28th November 2024

Re: 24/00962/DISCON LLFA Comments
MIRA Plot 44, Discharge Of Condition 29

This response has been prepared to respond to LLFA consultation prepared by Harvey Speed dated 22nd November 2024, reference 2024/0960/04/Fdis.

MTP PHASE 1 INFRASTRUCTURE
PROPOSED
SURFACE WATER
DRAINAGE STRATEGY

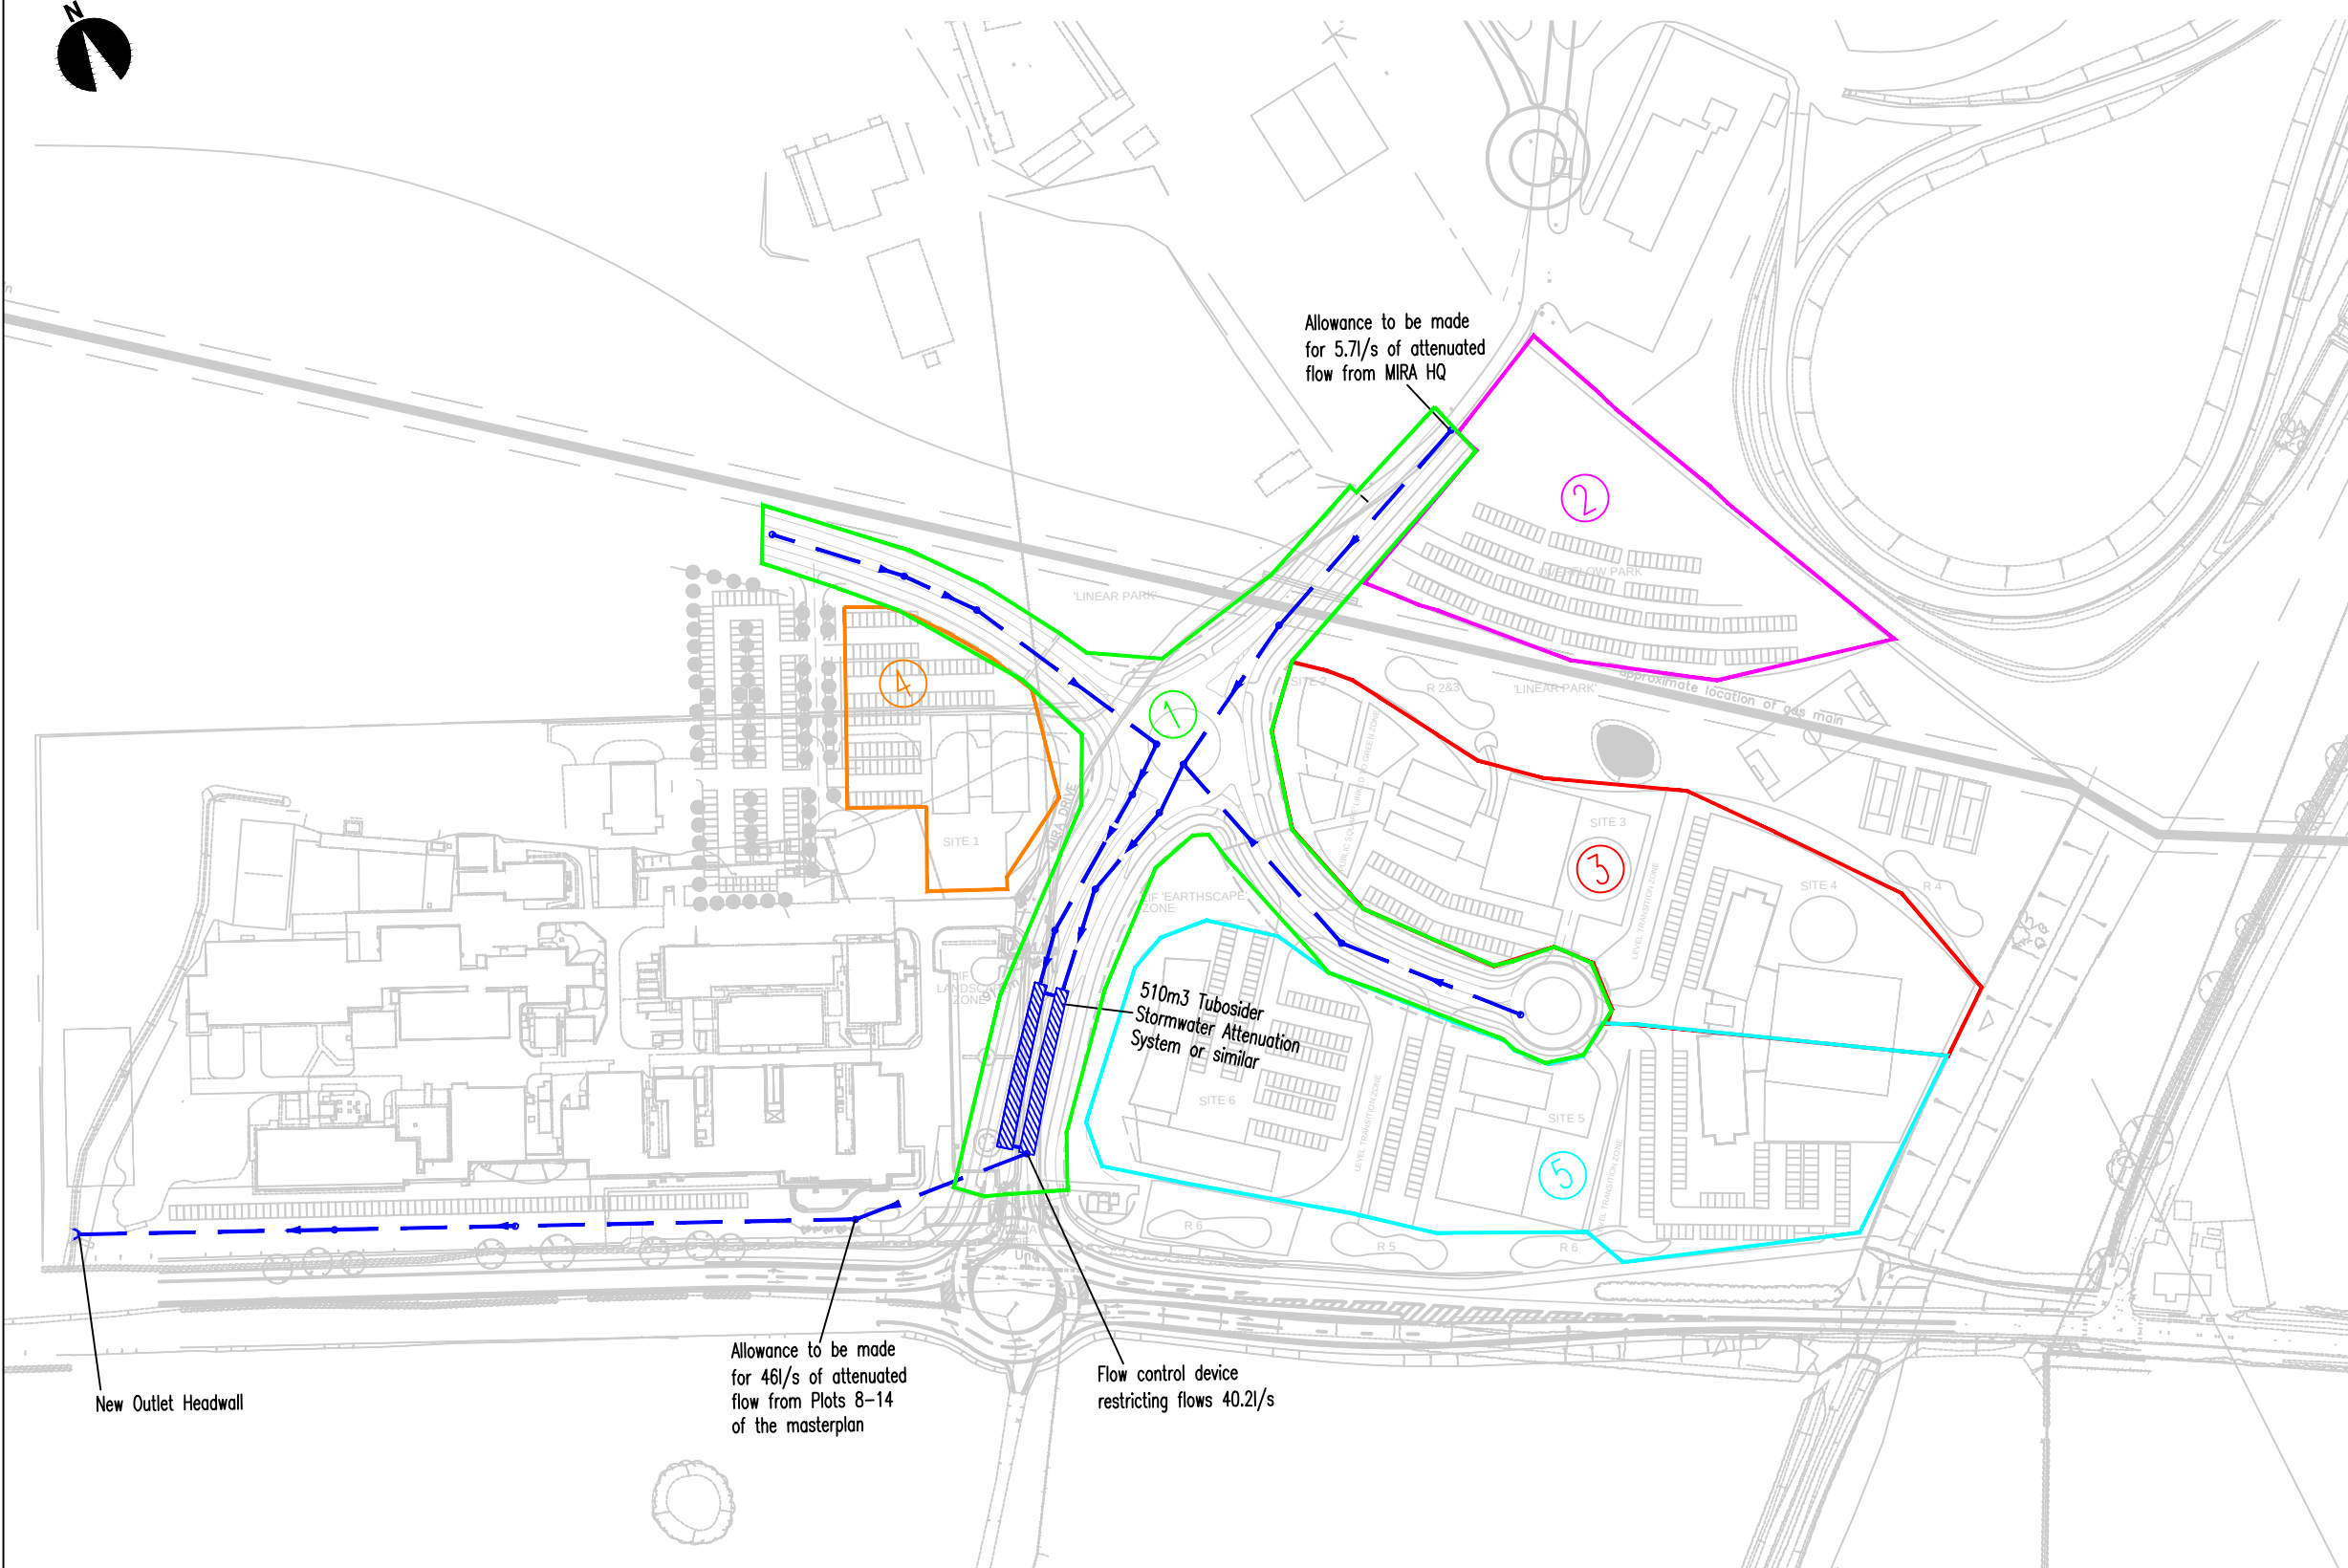
Whilst the masterplan has developed since the FRA, the principle of the overall strategy remains the same. It's understood that catchment 3 (land to the North of existing road infrastructure) outfalls directly to the road surface water sewer (as the Technology building approved planning, 14/00661/CONDIT) whilst catchment 5 (land related to future Southern plots) will outfall to the cascading ponds mentioned, in-line with the topographical falls of the wider site. Plot 44 has been considered a part of the Northern catchment and therefore is intended to outfall into the sewer network within the roads.

Plot 44 water treatment has been considered on-plot through SuDS methods such as permeable paved parking bays and filter drains. A further measure included is an interceptor that will assist in pollution control for the concrete yard.

P01	04:11:14	ISSUED	PJ
Rev	Date	Description	By
Amendments			
Project			
MIRA TECHNOLOGY PARK			
Title			
MASTERPLAN SURFACE WATER DRAINAGE STRATEGY			
Client			
MIRA LTD

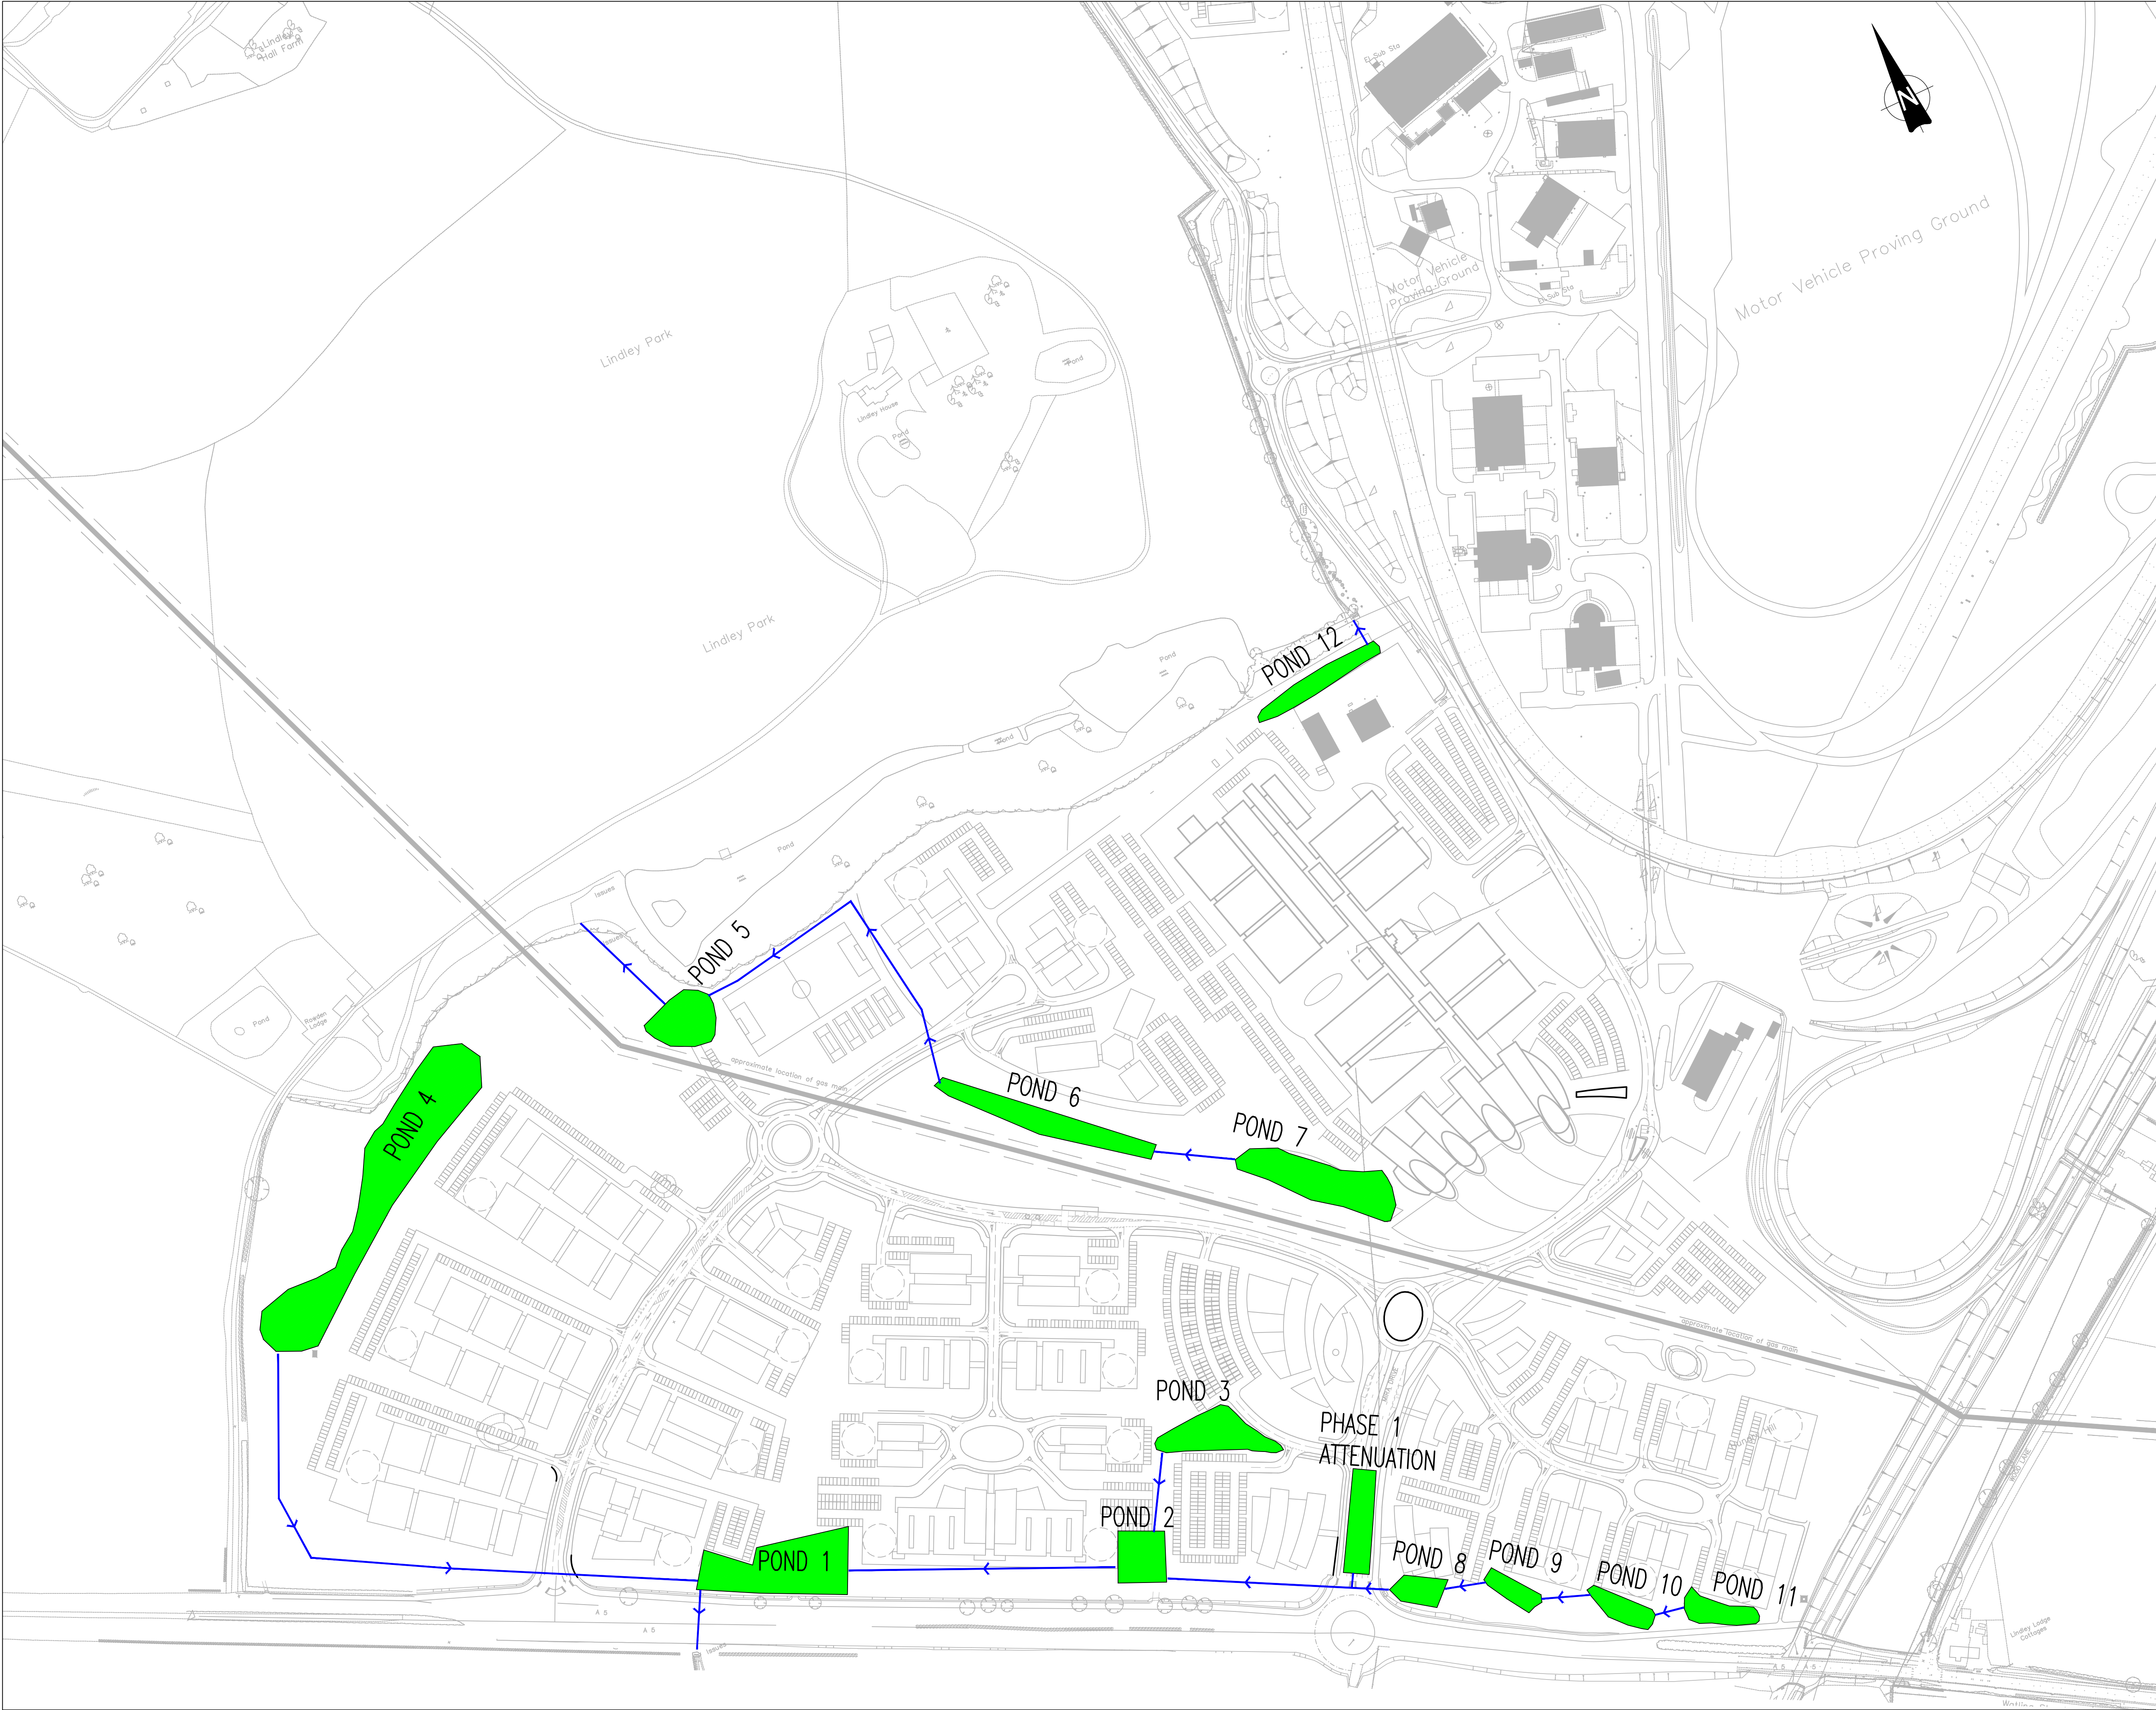
Regarding the southern ponds, these will still be implemented on the site keeping in-line with the agreed masterplan strategy (22/00889/DISCON) for future southern plots (catchment 5). They will provide on-plot attenuation, but the final design of these will not be confirmed until the detailed design of the future plots to suit water storage requirements, earthworks and the phasing of works.
